AGENDA
PLANNING AND ZONING COMMISSION WORK SESSION
City Hall, 385 South Goliad, Rockwall, Texas
Council Chambers
October 29, 2019
6:00 P.M.

9. **SP2019-037 (David)**
Discuss and consider a request by Anna C. Blackwell of Carrillo Engineering, LLC on behalf of Eddie Martin of Retail Partners, LLC for the approval of a site plan for a strip retail center on a 1.1755-acre parcel of land identified as Lot 26 of the Lake Ridge Estates Addition, City of Rockwall, Rockwall County, Texas, situated within the *Ridge Road Retail Subdistrict* of Planned Development District 32 (PD-32), located within the Scenic Overlay (SOV) District, addressed as 2930 Ridge Road [FM-740], and take any action necessary.

Discuss and consider a request by LeeAnn Latimer on behalf of Dr. Steve Arze of Zaph & Ath Properties, LLC for the approval of a site plan for a medical office building on a 1.36-acre tract of land identified as Lot 2, Block A, Landing Point Addition, City of Rockwall, Rockwall County, Texas, zoned Commercial (C) District, located north of the intersection of Industrial Boulevard and Airport Road, and take any action necessary.

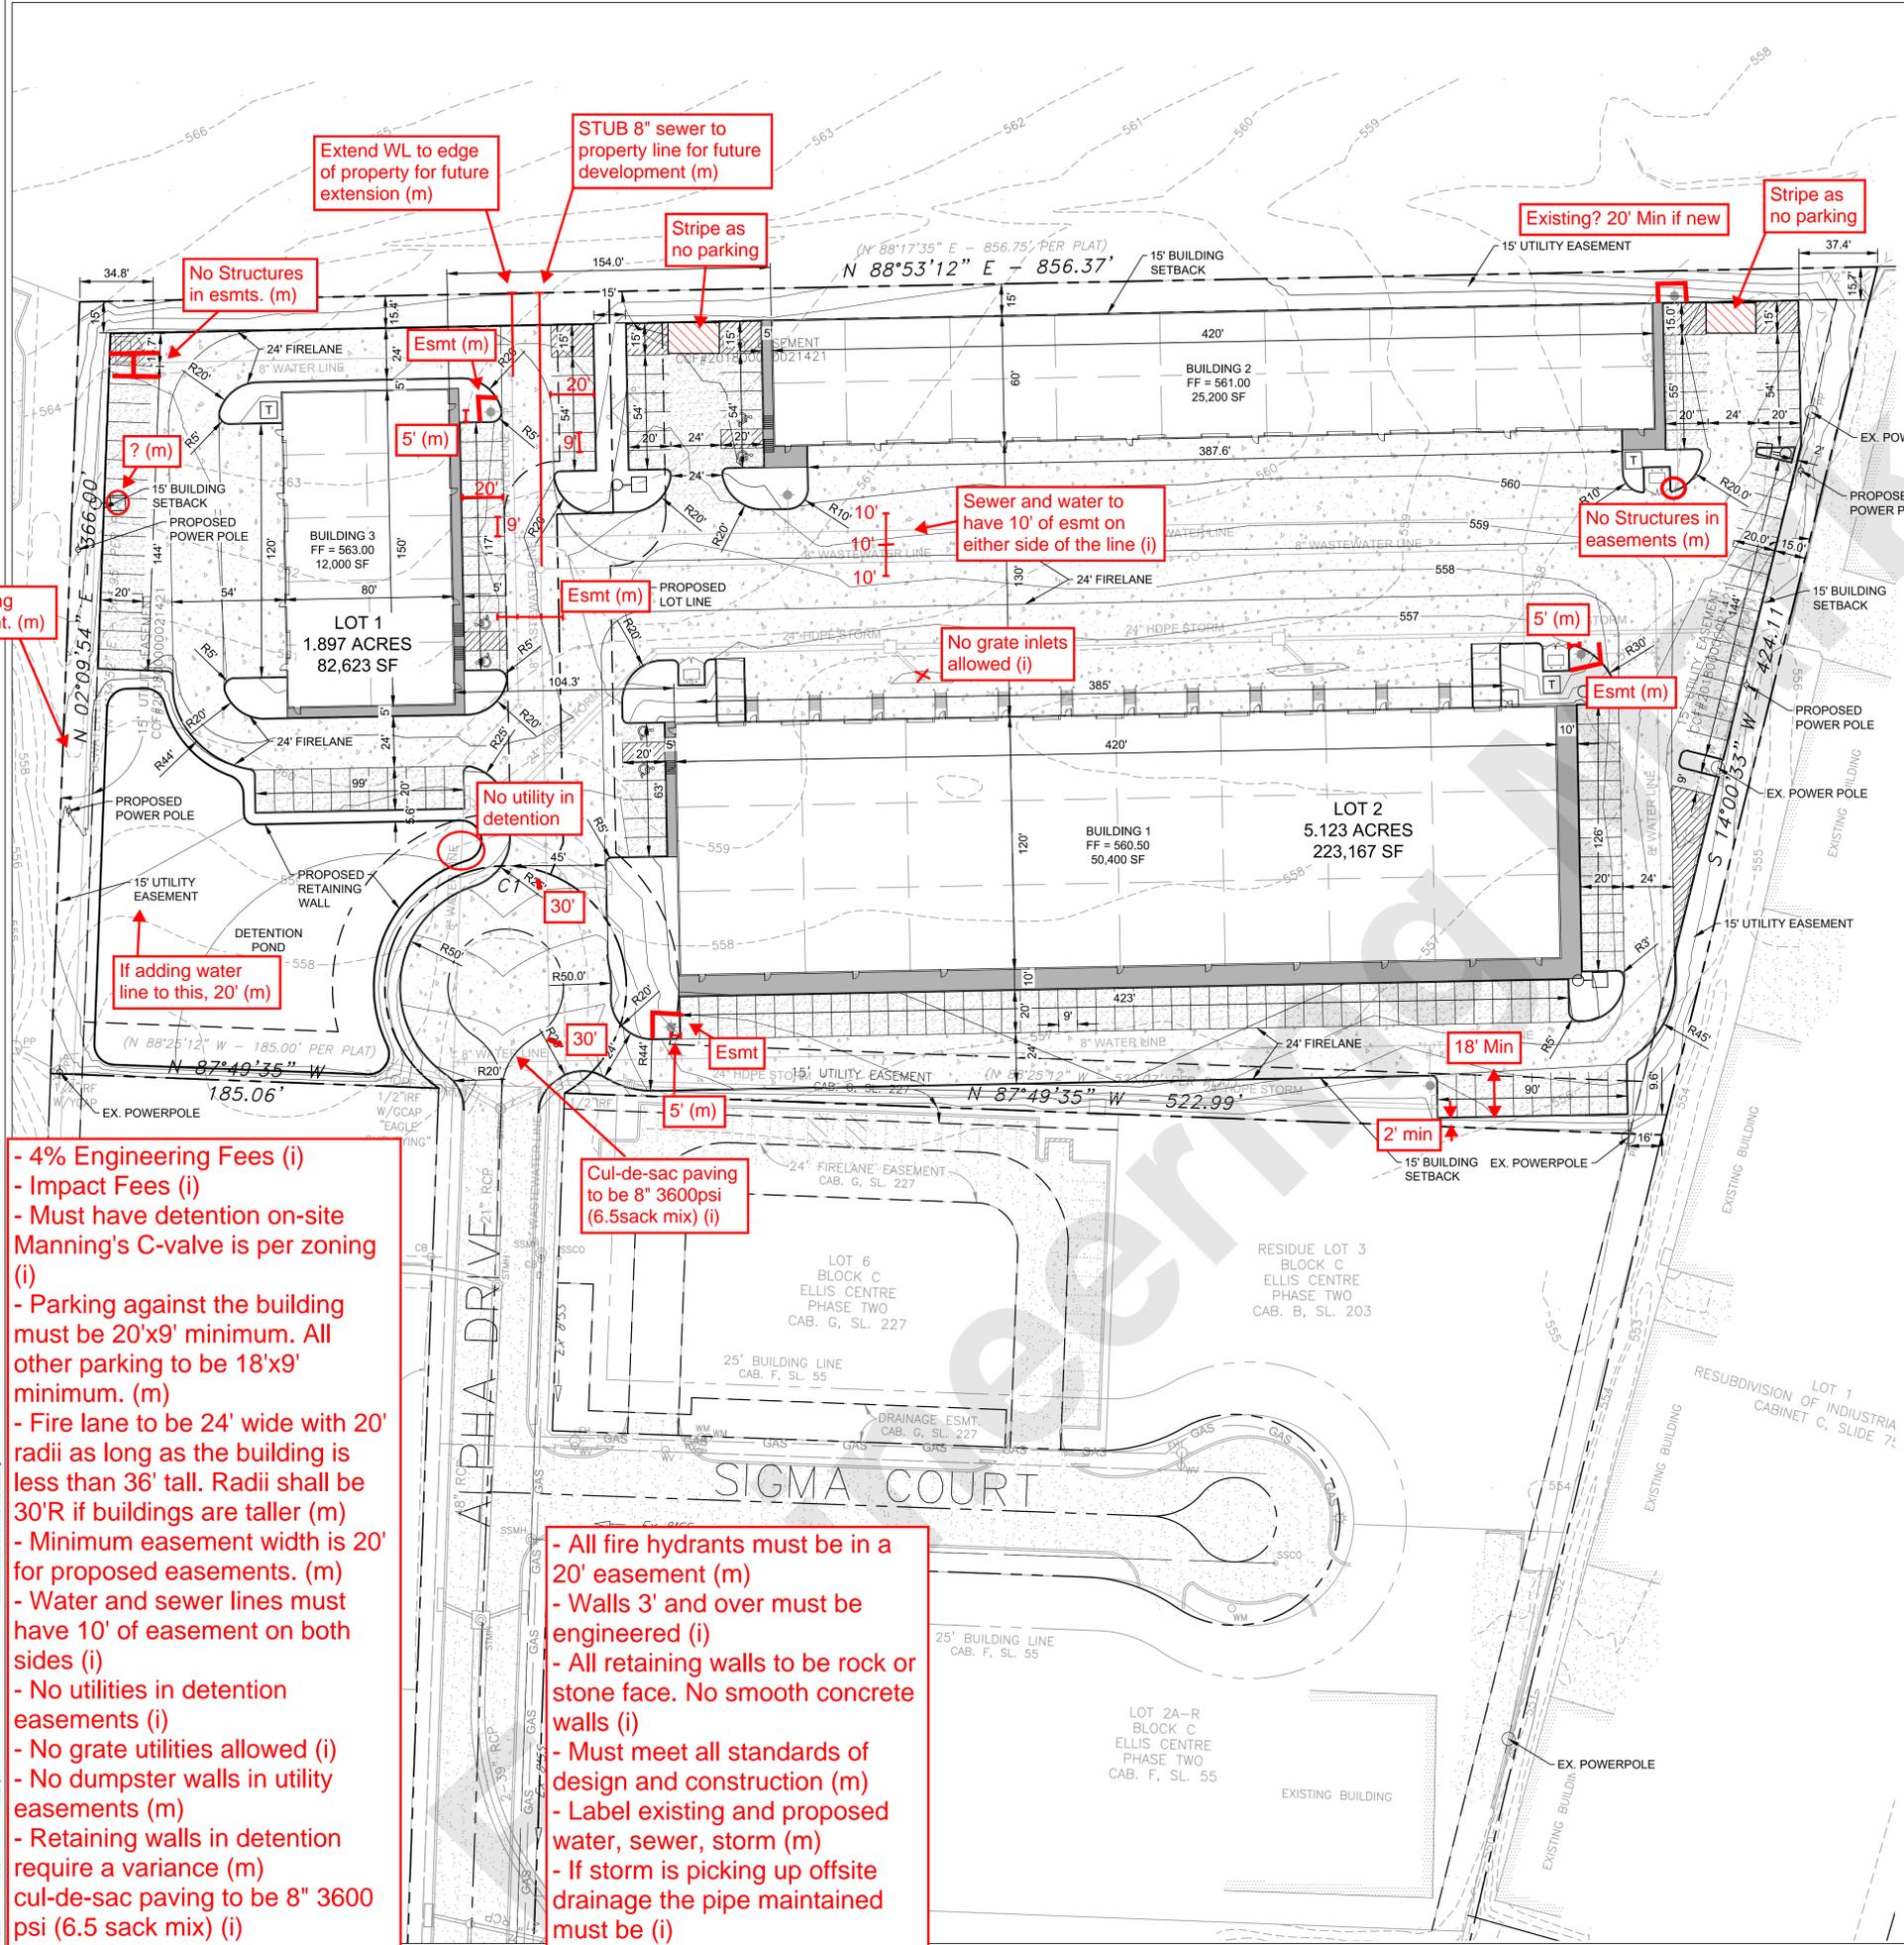
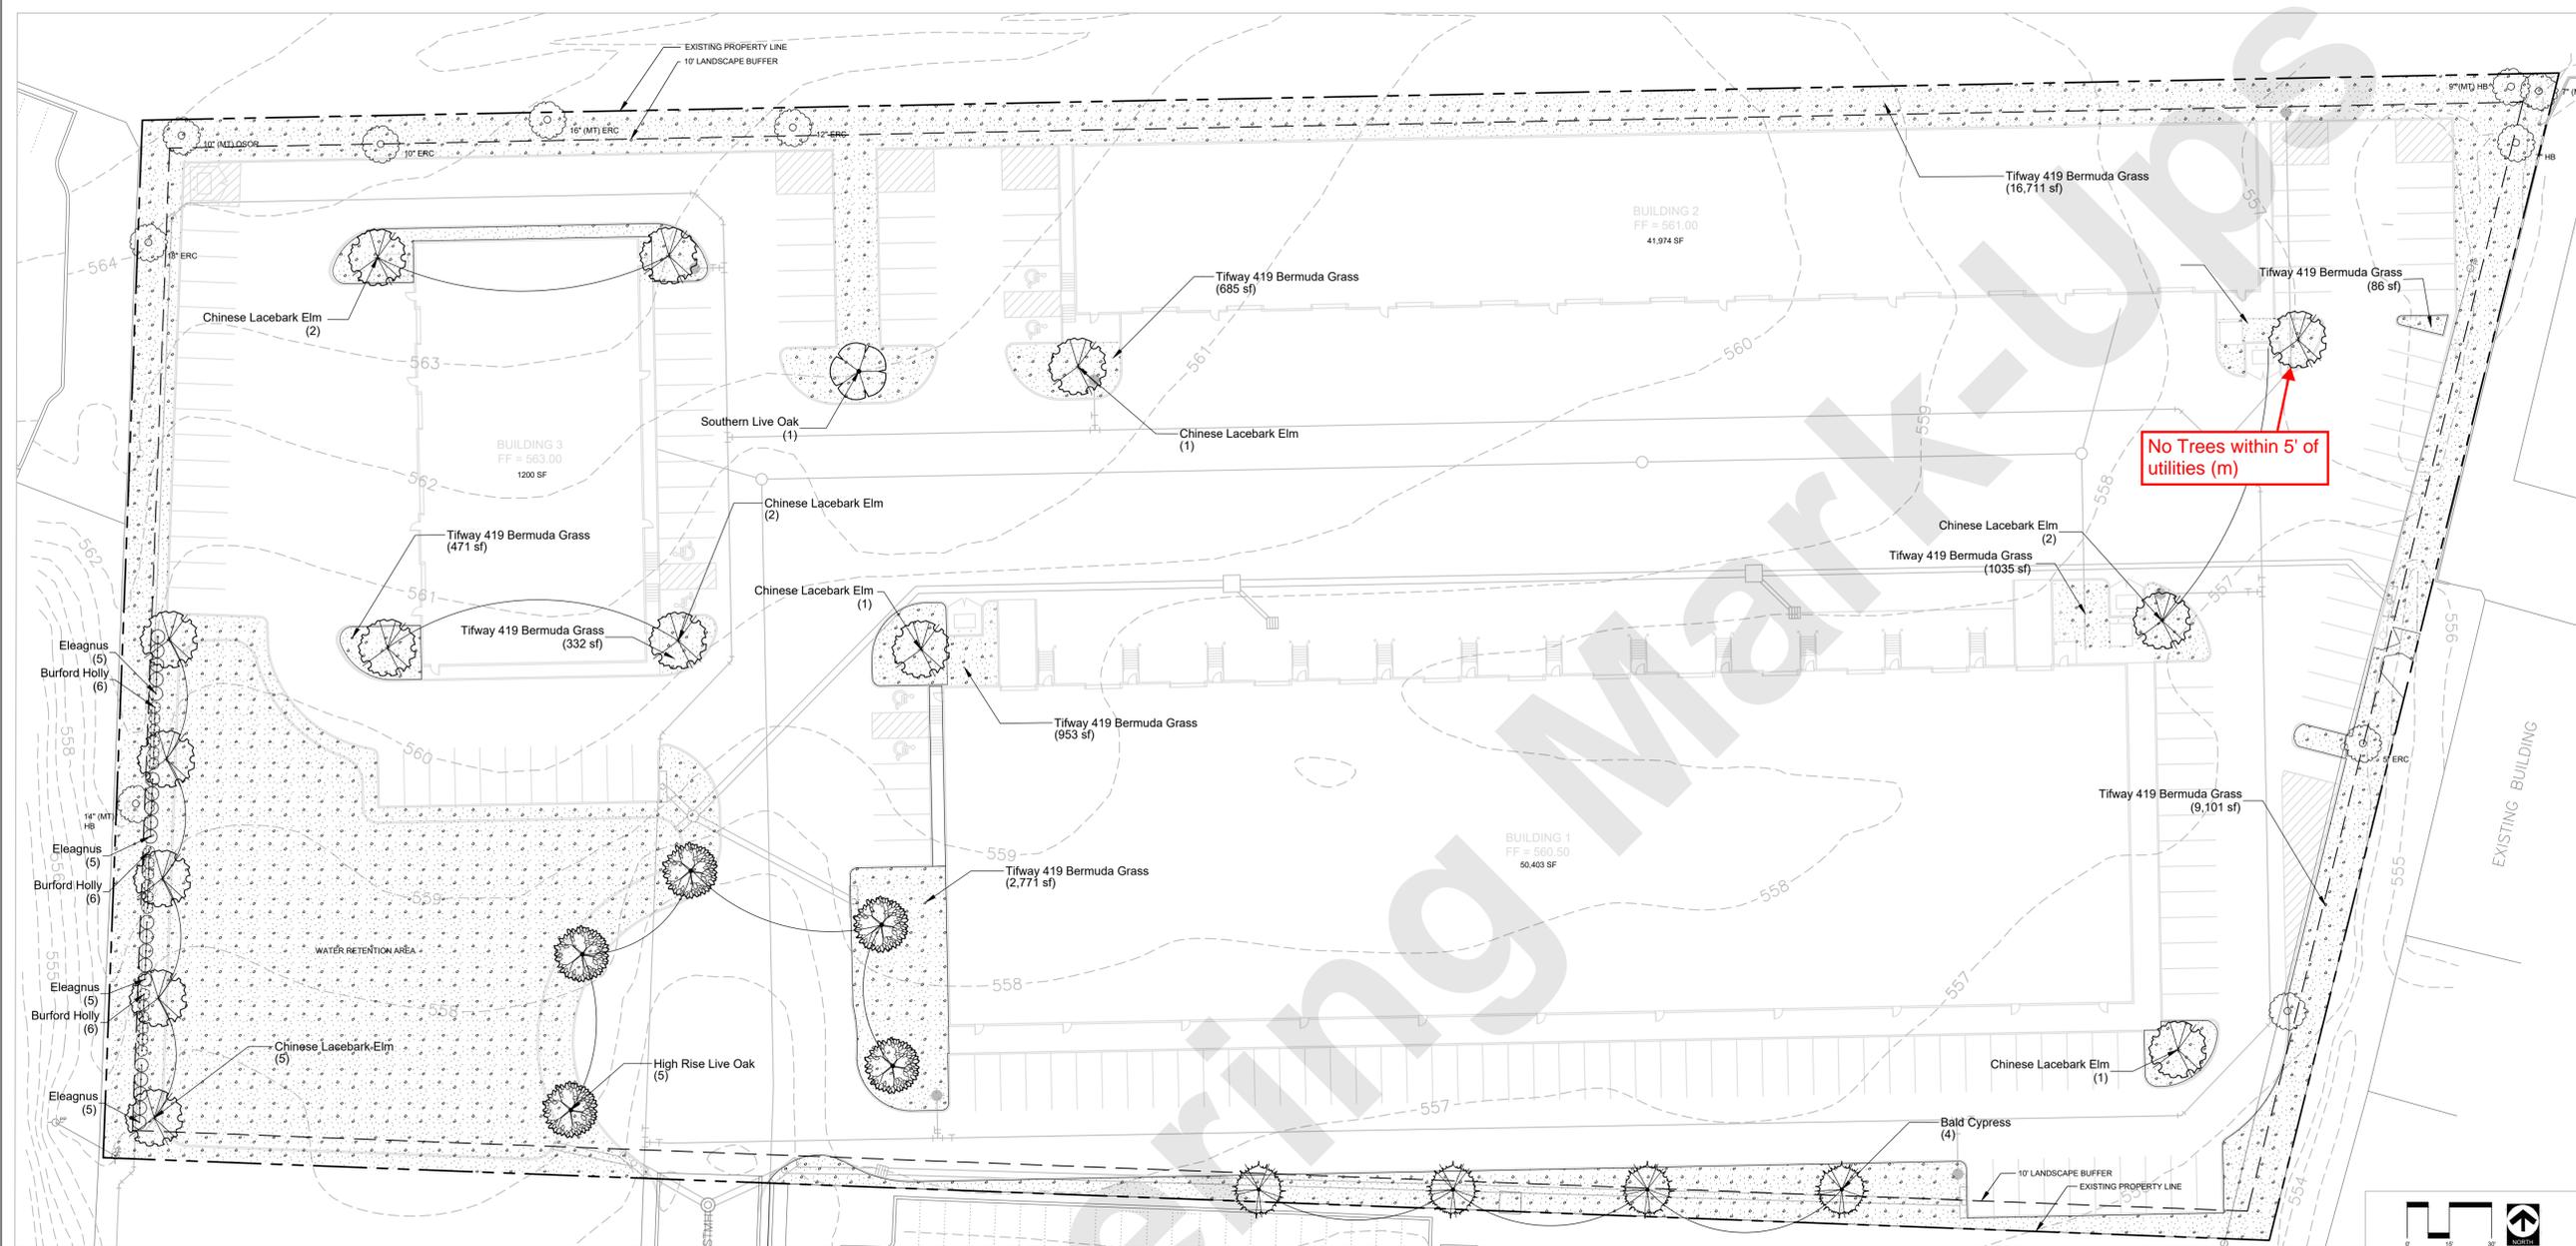
- 4% Engineering Fees (i)
- Impact Fees (i)
- Must have detention on-site Manning's C-value is per zoning (i)
- Parking against the building must be 20'x9' minimum. All other parking to be 18'x9' minimum. (m)
- Fire lane to be 24' wide with 20' radii as long as the building is less than 36' tall. Radii shall be 30'R if buildings are taller (m)
- Minimum easement width is 20' for proposed easements. (m)
- Water and sewer lines must have 10' of easement on both sides (i)
- No utilities in detention easements (i)
- No grate utilities allowed (i)
- No dumpster walls in utility easements (m)
- Retaining walls in detention require a variance (m)
- cul-de-sac paving to be 8" 3600 psi (6.5 sack mix) (i)

- All fire hydrants must be in a 20' easement (m)
- Walls 3' and over must be engineered (i)
- All retaining walls to be rock or stone face. No smooth concrete walls (i)
- Must meet all standards of design and construction (m)
- Label existing and proposed water, sewer, storm (m)
- If storm is picking up offsite drainage the pipe maintained must be (i)

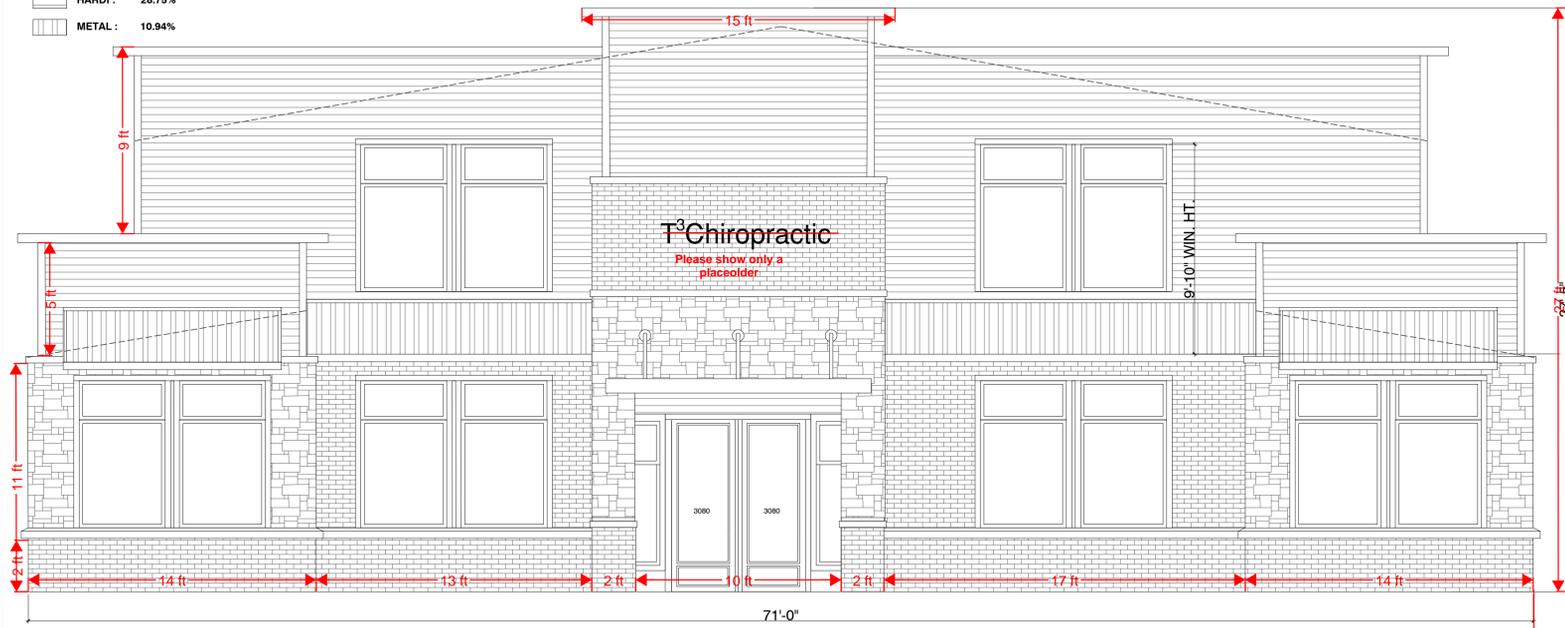
Type of Review / Notes	Contact	Sent	Due	Received	Elapsed Status	Remarks
GIS (10/22/2019 3:13 PM LS) Please use the 1503 Airport Rd (75087) address.	Lance Singleton	10/22/2019	10/29/2019	10/22/2019	APPROVED	See comments
PLANNING Please see markups	Korey Brooks	10/22/2019	10/29/2019	10/25/2019	3 COMMENTS	Comments
Police Department SP2019-041 Medical Office Considerations.	Police Department	10/25/2019	11/1/2019	10/25/2019	COMMENTS	Comments
<ul style="list-style-type: none"> • Consider additional security lighting at corners of building and dumpster(s) area. • Provide clearance around the bottom of the fencing surrounding the dumpster for visual sight line of anyone inside fencing. • Consider mirror(s) on dumpster fencing to reveal any persons inside holding (fencing) area. • Lighting placed on or in fencing area around dumpster to eliminate shadow and dark areas and prevent theft from dumpster (ID Theft, etc.) • Ensure that all lighting is positioned in a manner to minimize glare and reduce all shadows especially at the rear of business. • Consider auxiliary locking system on all entrance and exit doors with keypad or electronic badge requirement. • Consider the placement of bollards at the front of the front and rear of the business to keep a vehicle from being driven through these doors as a breaching tool. They should match the architecture. • Consider all exterior doors being equipped with alarm contact sensors and windows with glass break sensors. • Consider motion sensor alarms inside the business and motion activated lighting for the interior. • Consider installation of locking mechanisms/bars on rear doors during closed hours. • Consider installation of solid core doors for offices inside the business including the room that houses any monies or safe. Single cylinder locks for all offices and a double cylinder lock for the safe room. • Consider an additional alarm inside the safe room, either attached to the entrance door or safe. • Consider the addition of security cameras on the exterior of the building that provide 360 degree coverage and have IR capability. • Consider camera monitors for the rear of the business to ensure that employees will have a complete and unobstructed view prior to exiting into the rear parking area (Especially after hours). • Consider the addition of security cameras for the interior the business. • Ensure new trees andbushes are trimmed within acceptable standards (Trees Trimmed up to 7' and Bushes Trimmed Down to 3') and consider ground wash lighting to illuminate the area and provide territorial reinforcement, ownership and enhance natural lines of sight at night. • Consider ground wash lighting around the 10' landscape buffer to eliminate any shadows or dark areas. • Consider additional ground wash lighting around the building to enhance the look and further eliminate any shadows or dark areas. • Utilize plants around all first floor widows that will deter anyone from entering this area (e.g. native bushes or plants that have thorns). • More than willing to speak directly with the business owners or developers about the property. • Interior considerations are not being added without speaking with the business owners/ reps first.
